BASRAH MODERN SLAUGHTERHOUSE BASRAH, IRAQ

**SIGIR PA-09-189
APRIL 27, 2010**

Summary of Report: PA-09-189

Figures 2 and 3. Conceptual designs for the slaughterhouse project
(Courtesy of GRS)

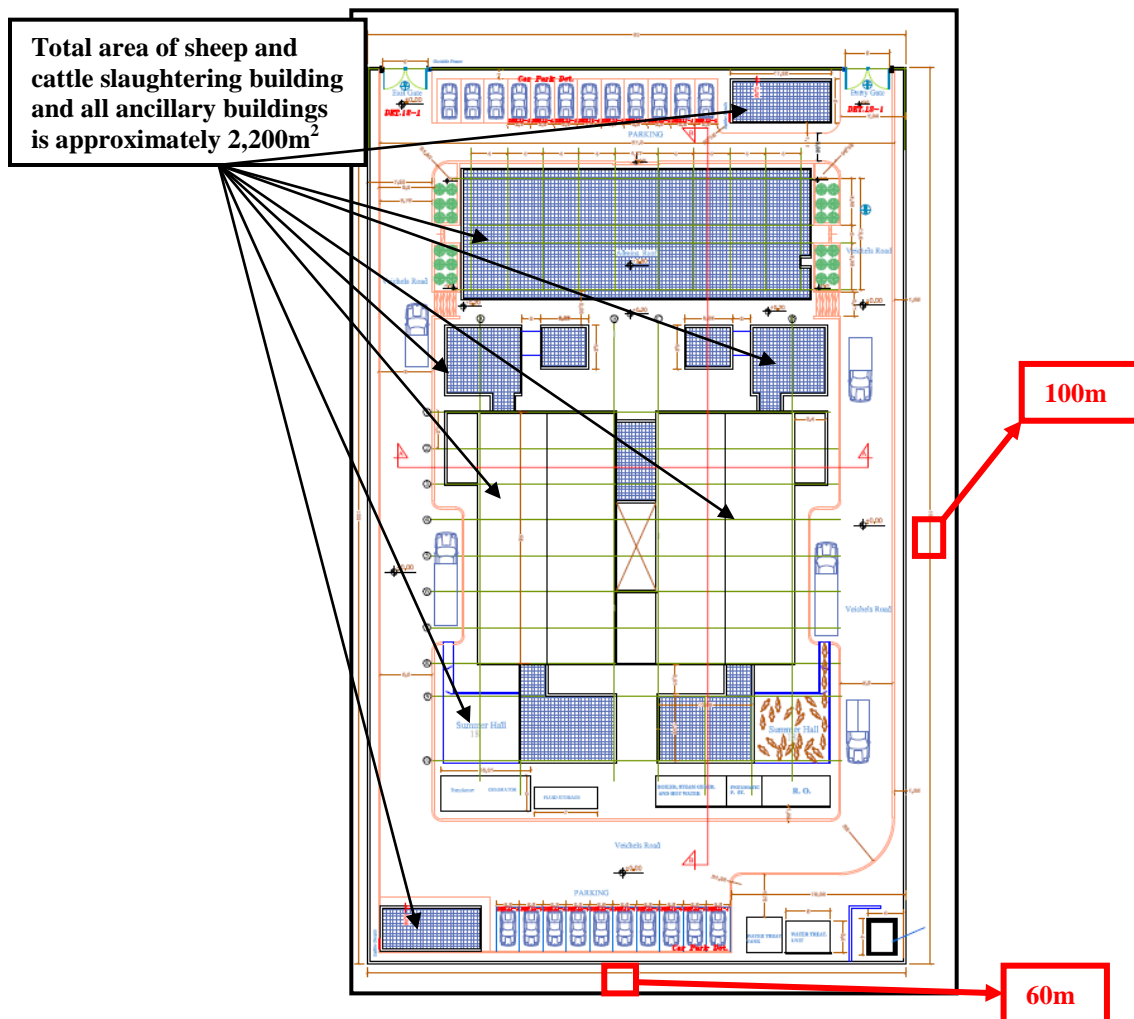
SIGIR reviewed the SOW and the GRS-provided conceptual designs. SIGIR found that the SOW lacked a process flow diagram to identify the required building sizes; while GRS provided two completely different types of slaughterhouse facilities as conceptual designs (Figures 2 and 3). One conceptual drawing indicates one slaughtering building; while the other conceptual drawing showed two slaughtering buildings. In addition, the conceptual designs left large gaps for personal interpretation.

As the designs were further disseminated through GRS, the project’s construction representative also identified two discrepancies. Specifically, “*the SOW calls for the ‘operational area’ to be twice the dimensions of the conceptual drawings. The dimensions of the conceptual drawings provide for an operational area of 1,728 sq. meters. Your [the contractor’s] design shows an operational area of 840 sq. meters. This amount is about half of the area required by the contract.*”

"...the SOW lacked a process flow diagram to identify the required building sizes; while the GRS provided two completely different types of slaughterhouse facilities as conceptual designs (Figures 2 and 3). One conceptual drawing indicates one slaughtering building; while the other conceptual drawing showed two slaughtering buildings..."

The resident office provided SIGIR all project documentation which contained two conceptual drawings. However, the Contracting Office at GRS headquarters maintained the official contract file and the set of drawings that were referenced in the solicitation's statement of work. The Contracting Office only issued one conceptual drawing, figure 2 on page seven of the report, with the solicitation. The Contracting Office used the conceptual drawing that illustrated one slaughterhouse building whose dimensions were 15m x 30m.

Had SIGIR used the conceptual drawing contained in the official contract and project files, figure 2 on page 7 of the report, their computations would have agreed with the contractor-submitted proposal.

The conceptual drawing to which the construction representative was referring was not the conceptual drawing on which the contractor bid. The construction representative referenced an older conceptual drawing (figure 3 on page 7 of the report), not the official drawings. The older conceptual drawing which was never included in the contract contained two slaughterhouses; each measured 14.6m x 29.6m or 432.16m². Using the older conceptual drawing and doubling the operational area, as the statement of work required, would yield an operational area of 1,728.64m² - 2 buildings x (2 x 432.16m²); the area the construction representative noted and SIGIR quoted in its report. However, the official SOW referenced a conceptual drawing with building measurements of 15 m x 30m. The contractor submitted drawings showing two similarly sized buildings which he subsequently built. Based on these facts no equitable adjustment is due for the building size.

Figure 5. Design indicating path of blood from the blood storage tanks to the “Water Treatment Unit” (Courtesy of GRS)

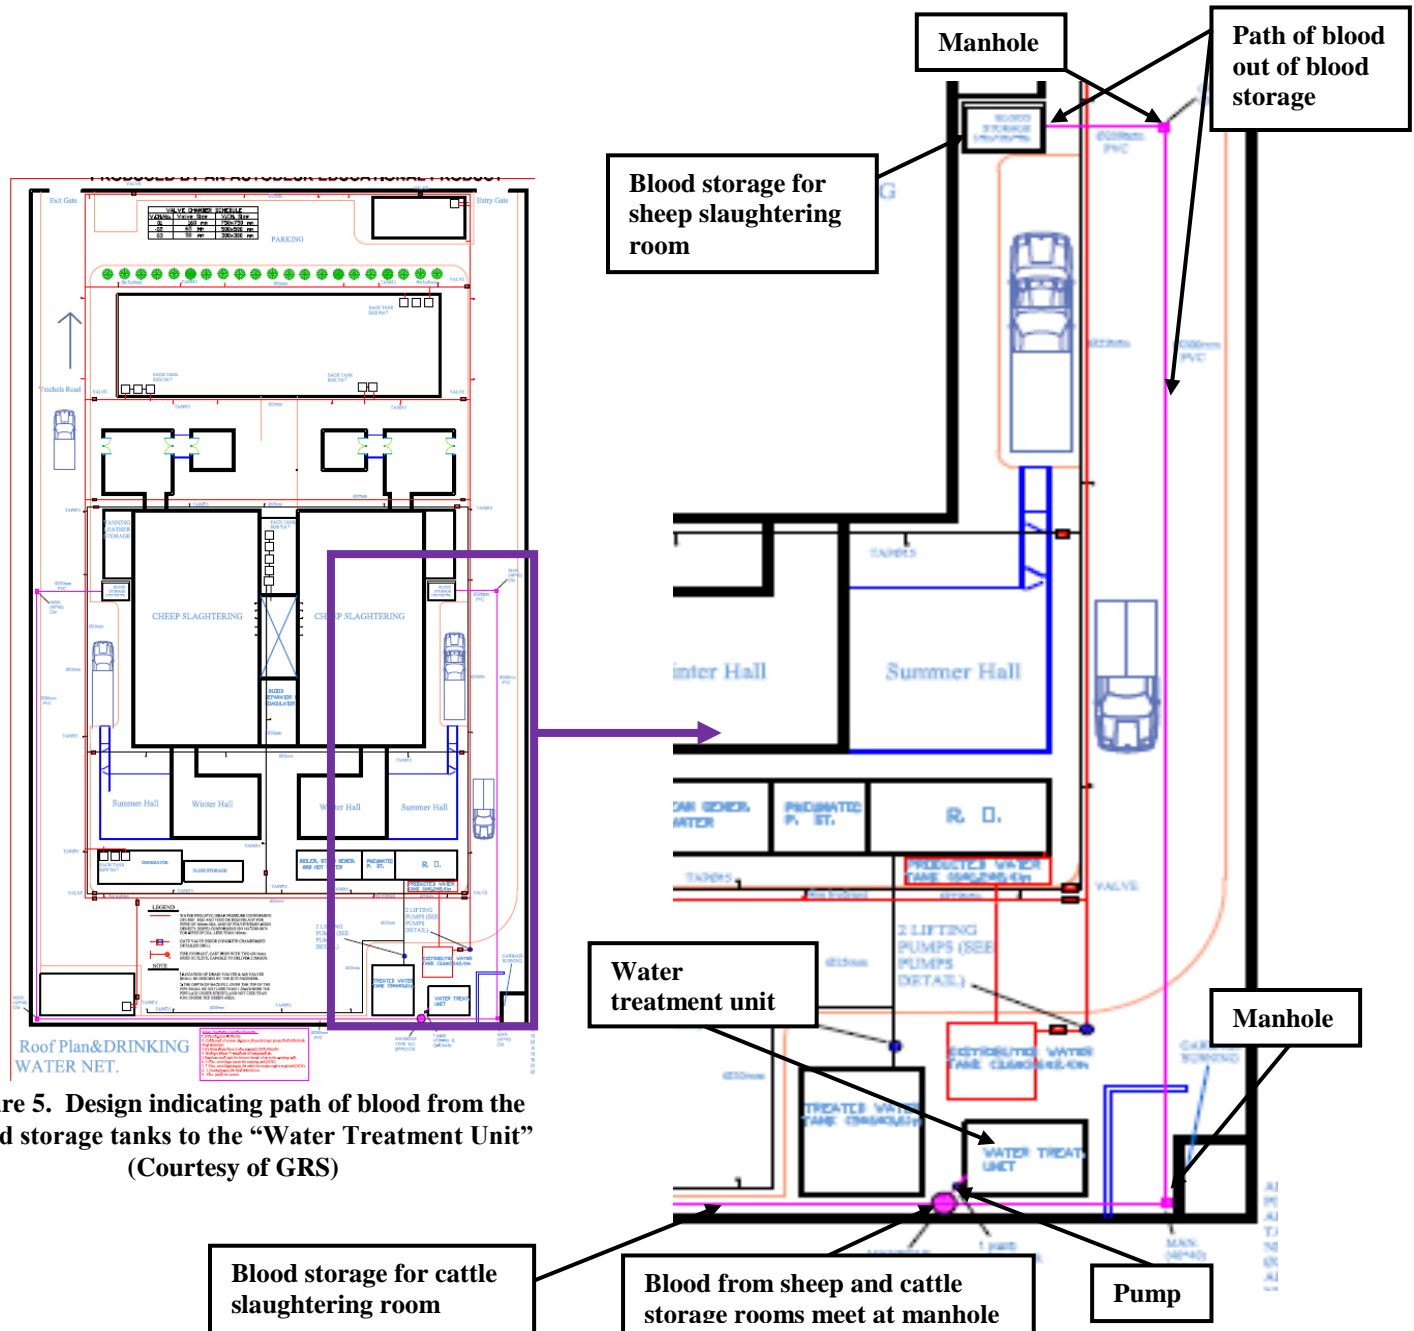
Typically, a slaughtering and meat processing facility uses a significant amount of wash down water to maintain the facility's cleanliness. From the contractor's S-2 drawing, it appears that the trench drains intercept the runoff from the production floor of the facility. The drawings further indicate that this drain is directed to blood storage tanks on either side of the facility. The contractor did not provide sizing calculations for the blood storage tanks, conveyance lines, or processing equipment;

The contractor's drawing S-5 shows the blood storage tank contents conveyed via a 200 millimeter pipe to the "Water Treatment Unit." However, screening of the effluent from the storage tanks is not indicated on the plans. This will present a maintenance issue with the lines to the treatment unit if clotting of the blood is permitted in the tanks.

In addition, SIGIR is concerned that the blood and waste products from the production floor wash down is being directed to the Water Treatment Unit (Figure 5). Based upon the BOQ, this unit is for disinfection and treatment and is probably not appropriate for treating blood. A "Blood Separation and Coagulation System" is specified in the BOQ; however, the contractor did not address the capability and location of this equipment.

"The contractor's drawing S-5 shows the blood storage tank contents conveyed via a 200 millimeter pipe to the "Water Treatment Unit." However, screening of the effluent from the storage tanks is not indicated on the plans. This will present a maintenance issue with the lines to the treatment unit if clotting of the blood is permitted in the tanks."

and storm water network. Drawing P-6 (Washing Water Network) cleared showed the blood separation and coagulation system.

Figure 6. Site power distribution plan without guardhouse (Courtesy of GRS)

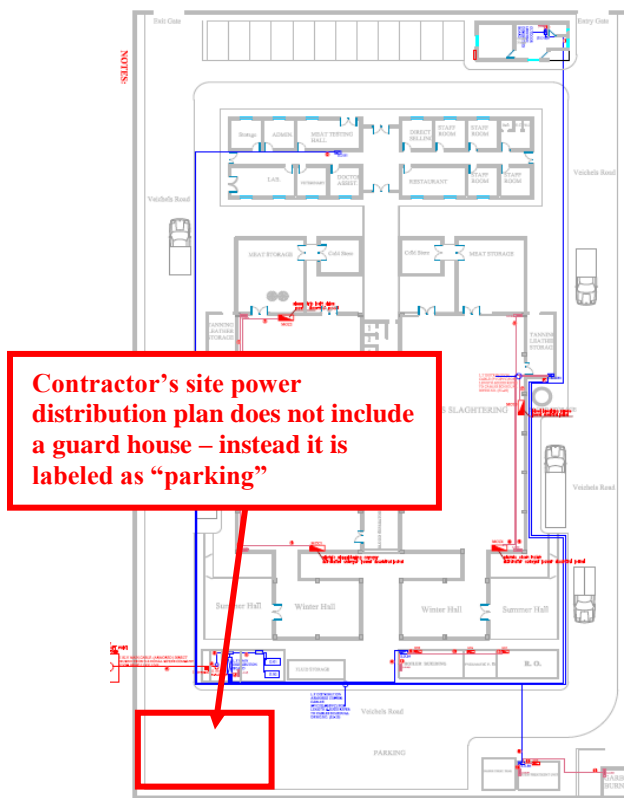
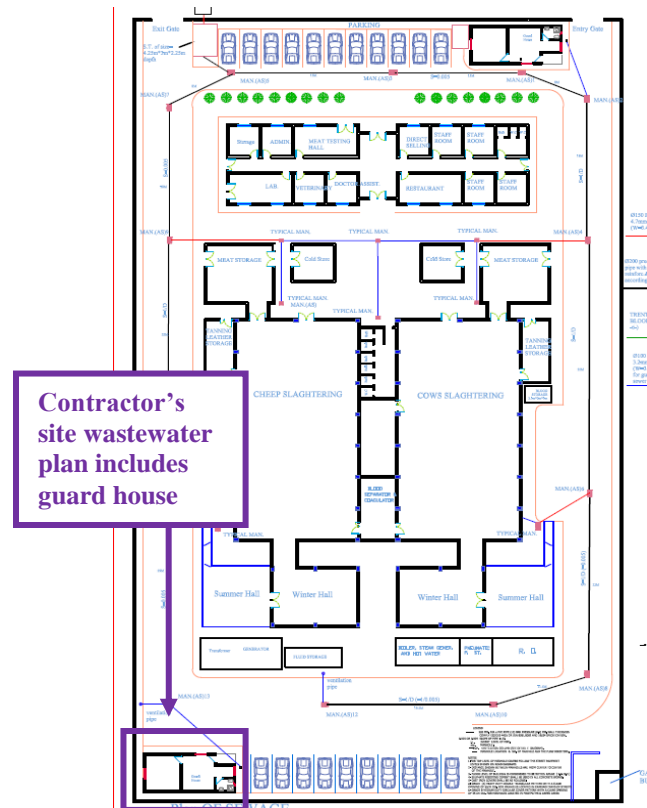
The SOW required the construction of two guardhouses with electrical fixtures and plumbing. However, on the contractor's 100% "Site Power Distribution Plan," there is only one guard house (Figure 6). The second guard house in the southeast corner is included in a majority of the contractor's other 100% drawings (Figure 7); yet for some reason the entire guardhouse is missing from the Site Power Distribution Plan. As a result of this omission, the 100% plan obviously does not illustrate the required electrical connections or fixtures to this guard house.

Figure 8. Design of perimeter fence
(Courtesy of GRS)

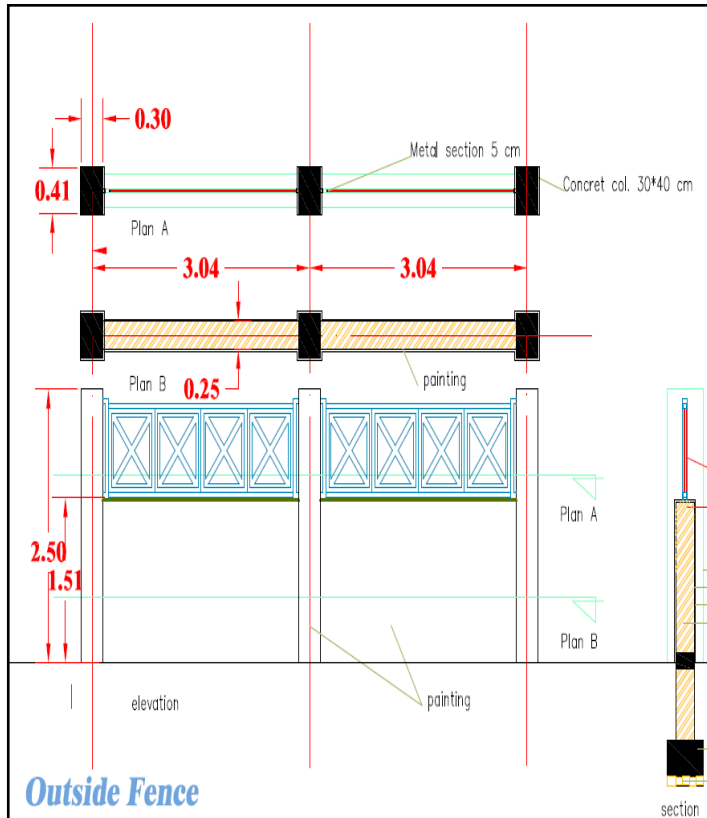
The contractor's design required the perimeter fence consist of reinforced concrete foundation, columns, and metal trusses between the columns. Concrete masonry unit panels, covered with cement mortar and stucco, were constructed between the columns to form a solid barrier (Figure 8).

At the time of the site visit, the perimeter fence was partially complete (Site Photo 3). The fence appeared to be adequately constructed, and when finished, should provide security for the slaughterhouse operators and equipment, as well as, from stray dogs and rodents attracted by the slaughterhouse.

**Figure 9. Contractor's detail for placement of lintels for doors and windows
(Courtesy of GRS)**

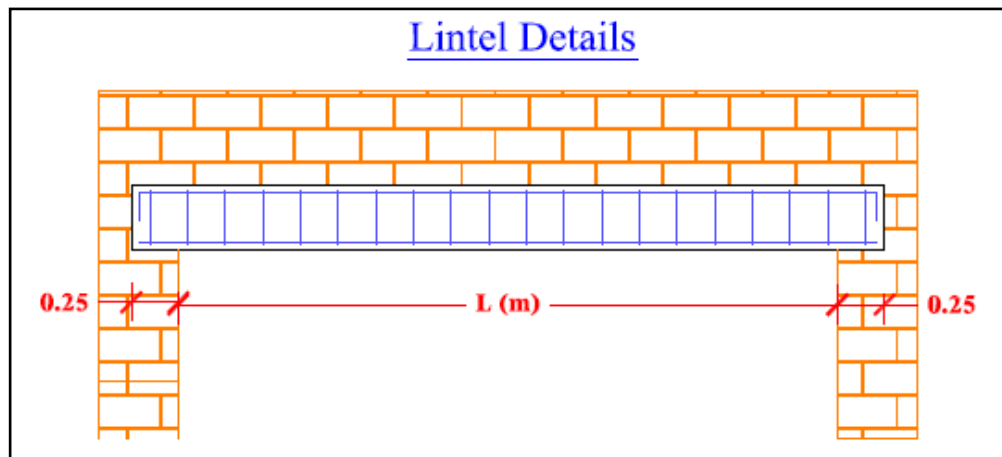
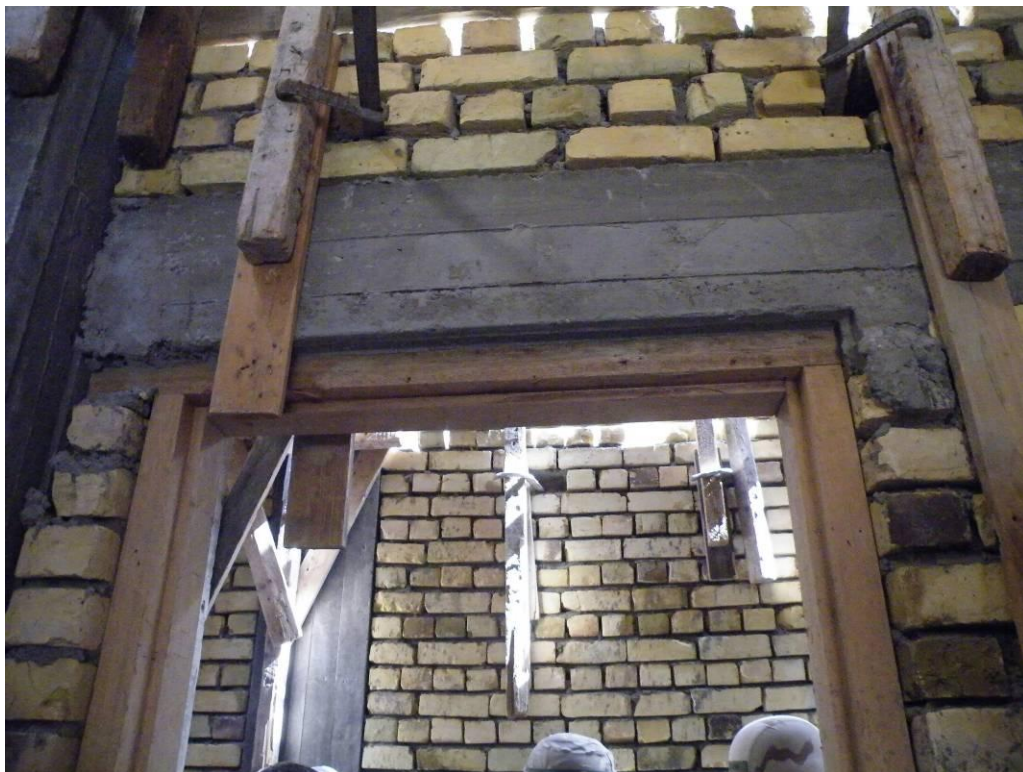
SIGIR identified potential issues with the contractor's placement of lintels and tie beams¹¹. The contractor's structural drawing S1 required lintels for all doors or windows to have at least 25 centimeters (cm) of bearing on the brick masonry supports (Figure 9). During the site visit, SIGIR identified several locations where lintels for door openings were not placed according to the contractor's structural drawings (Site Photo 4).

SIGIR's concern is that these lintels do not offer sufficient support and may result in failure of the brick masonry supports. SIGIR brought this issue to the attention of GRS. After reviewing the issue, GRS responded:

The lintel detail shown on sheet S1 is a generic detail. Where the door or window fell close to the frame of the building and the required length of brick could not be obtained, one end of the lintel was doweled into the column for vertical support only. All free ends of lintels have more than the required 25cm. A detail of the individual lintel placements shall be provided.

SIGIR believes that dowels, if properly utilized¹³, would provide the necessary support for lintels with less than 25cm of brick length. Since GRS is certifying that the contractor appropriately used dowels, then this issue has been adequately addressed.

Figure 10. Structural design for intermediate beams

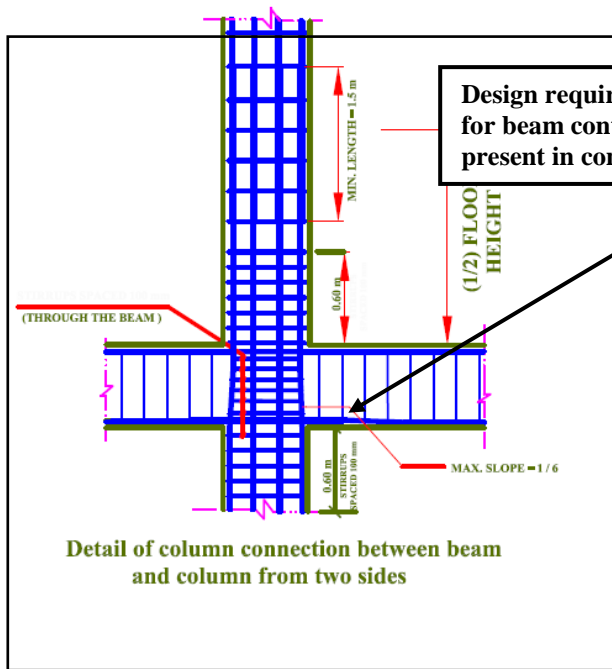
After reviewing the structural details on drawing S3, SIGIR determined that the contractor's design lacked specific details for the intermediate beams for column lines A, B, C, and D. It appears that these beams are intended to brace the associated columns and tie them to the brick masonry. Based upon SIGIR's observations, it appears that the intermediate beams are generally placed at a height of approximately 2.5m from the finished floor level and are not tied to the columns.

Structural sheet S3 provides general details for the intermediate beams showing the general arrangement of reinforcement, and placement sequence. Specifically, the details indicate that the placement of the reinforcing steel for the beam is to be continuous through the column (Figure 10). This can only be achieved if the reinforcement for the beam is placed prior to casting the column.

Based on SIGIR's review of daily QA and QC reports, and observations made during the site visit, it does not appear that the contractor constructed the intermediate beams according to the approved design drawings. A photograph from a daily QA report shows form construction for columns without placement of intermediate tie beams in sequence as prescribed by the contractor's design drawings (Site Photo 6). No reinforcement is evident in this photograph extending through the column into the intermediate beam.

SIGIR's concern is that without the positive connection between the intermediate beams and the columns, as required by the contractor's design drawings, the reinforced concrete columns and the brick masonry infill may be overloaded. The intermediate beams should provide lateral stability to the columns, increasing their load carrying capacity. If the design of the columns relied on this support, they may be overloaded in their current configuration. It also appears that the intermediate beams were intended to carry the load of the upper panels of brick masonry infill. This intermediate support would relieve vertical load on the lower panel of brick infill and would halve the effective height of the wall, reducing the susceptibility of the brick masonry to buckling.

The tie beams shown on sheet S-6 were in conflict with the plumbing for the entire facility. The original design called for 2 five meter tall main structures tied together in the middle by a 3 meter tall bathroom area. With the conflict in plumbing the buildings were constructed as 2 independent main structures with

an independent bathroom built in the middle. This eliminated the need for tie beams shown on sheet S-6 and intermediate beams on S-11. This revision shall be provided.

There were no intermediate beams designed for column lines A or D. The intermediate beams that the details on S-3 show, were beams that were originally planned for column lines B and C only. These beams were for the bath room area that is directly between the 2 main structures and they would have been placed at the eve height of the bathroom shown in the architectural details as 3 meters. The beams that you [SIGIR] are referring to in the main structure are bond beams for the brick walls. Under the best seismic circumstances a non load bearing exterior masonry wall can only have an unsupported height/width to thickness ration of 18. For a 25cm wall this would mean a max 4.5 meter height and 4.5 meter max width. The bond beams, dowels for the columns, and wire fabric are there to provide support for the masonry walls as per IBC [International Building Code] 2006 section 21. A detail of the walls with the bond beams, dowels, and wire fabric shall be provided.

The only beams that are tied into columns are the beams at the top of all the structures. These are all tied in properly. Again the referral here is to the bond beams for the walls in the 2 main structures which are not intermediate beams as shown in the general detail.

The drawings for Column lines A and D never had intermediate beams (see Sheet S-11 beams B4) and the design calculations never had any intermediate beams...The overall structural design for the Basrah Modern Slaughter House was reviewed by a Licensed Structural Engineer [with the U.S. Army Corps of Engineers]....
